**Planning Commission
Staff Report**

July 10, 2013
Item 6.a.

- SUBJECT:** PUD-97
- APPLICANT:** Ponderosa Homes / Pamela Hardy
- PROPERTY OWNER:** Thrivent Financial
- PURPOSE:** Application for rezoning of an approximately 2.1-acre site at 4202 Stanley Blvd from C-F (Freeway Interchange Commercial) District to PUD-MDR/OS-PH & WO (Planned Unit Development – Medium Density Residential/Open Space – Public Health and Wildland Overlay) District and for PUD Development Plan approval to retain the existing residence, remove the washroom structure with residential unit, storage accessory structure, and the 32 mobile home spaces (hook-up, concrete pads, etc.), to construct 12 detached single-family homes.

Figure 1: Preliminary Review Site Plan

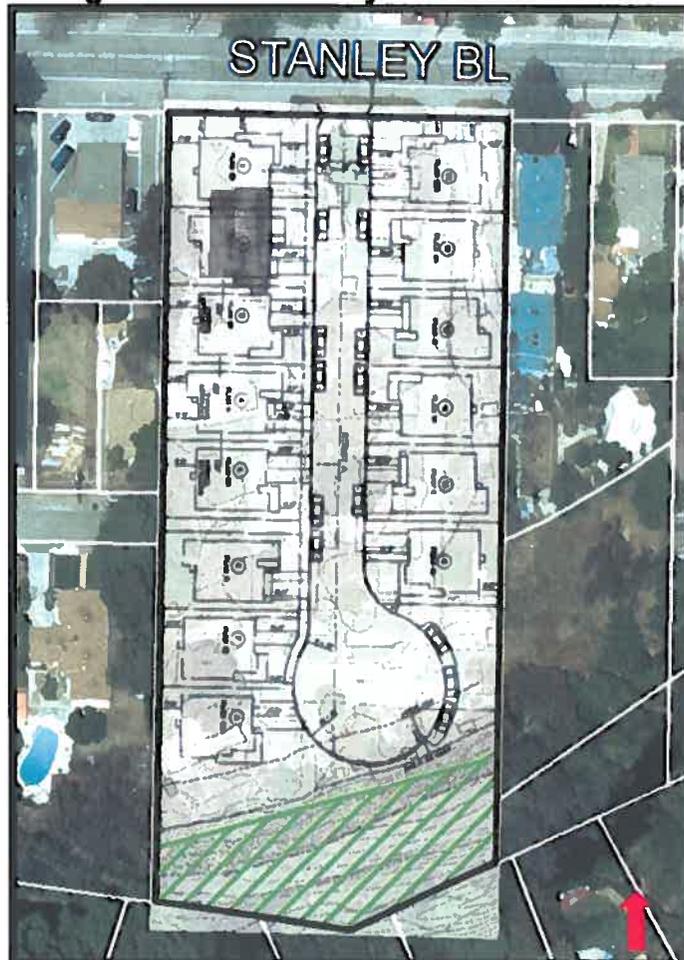
The Commission felt that the proposed private pedestrian walkway to Vervais Avenue, located on the south side of lot 5, shown in Figure 1 on page 2, was not beneficial to the public and, therefore, not necessary since it would not be a public amenity.

Figure 7: Tree Survey with Proposed Tree Removal

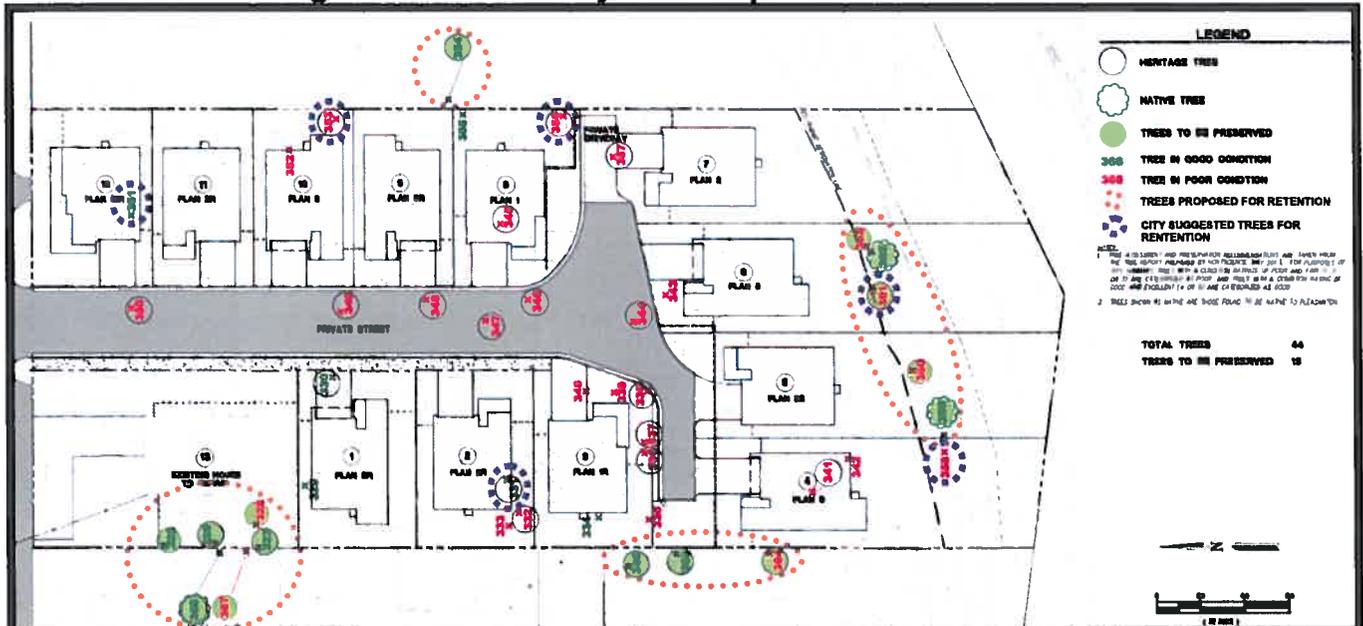
The City's Landscape Architect, Mike Fulford, reviewed the tree report for the proposed development (Exhibit E) and conducted a site visit to the subject property to confirm the observations/summary that was prepared by HortScience. Mr. Fulford agrees with the estimated value of the trees, the health observations and other conclusions regarding the on-site trees. As indicated in the tree report, many of the trees are 'not suitable for preservation' based on the fact that they are located in areas that are proposed for development (i.e., building envelopes, roadway, etc.). Mr. Fulford noted that many of the trees that are 'not suitable for preservation' that are proposed for removal are "excellent specimens" and if the site plan were to be re-worked the trees could/should be retained. These trees include:

The trees referenced above are circled in purple in Figure 7 (above). If the applicant were interested in rearranging the lot layout, the trees noted above could be saved.

Mr. Fulford believes that all of the trees located along the steeply-sloped creek bank should be retained. He also noted that the large Paradox walnut, located on the adjacent property to the east (tree #354), is an unusual and "magnificent" specimen and will require significant pruning in order to accommodate the proposed development and due to the sensitive nature of this species, its survival is questionable. The tree has an appraised value of \$12,700 and Mr. Fulford would like the Tree Preservation Guidelines presented in the Report to be followed meticulously.

Ponderosa will be required to remit the full appraised value of all trees to be removed, similar with other development projects they have constructed in Pleasanton, and a bond, or other financial security acceptable to the City, will be required for no less than two years after project completion to ensure the survival of the trees to be preserved (both on- on off-site). A condition of approval has been added to reflect these requirements.
